REFERENCE	BT_2013_FR1.6_3_UK	
DATE	26 September 2013	
SUBJECT	Technical advises and rules update	
PART

## Technical bulletin only applicable for FR1.6 NEC Junior and Nordic championships.

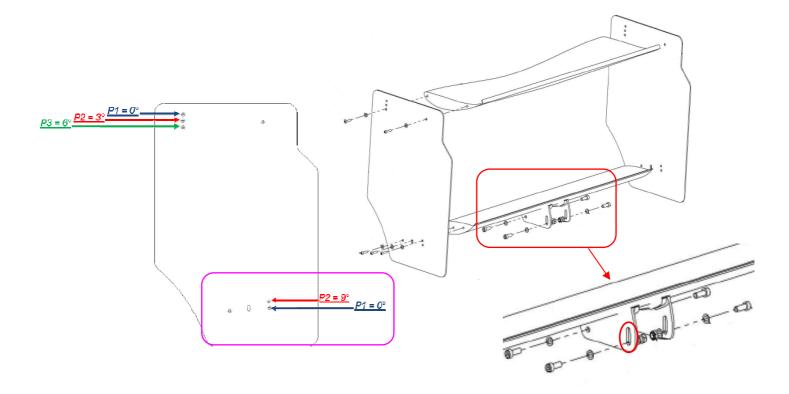
The chassis reference plane and the endplate reference plane must be parallel (angle=0°±1°) and must be measured using a digital level following the procedure below:

- - II. Rear wing endplate reference plane: Top edge of the rear wing endplate The digital level must be positioned on the top edge of the endplate as shown below:
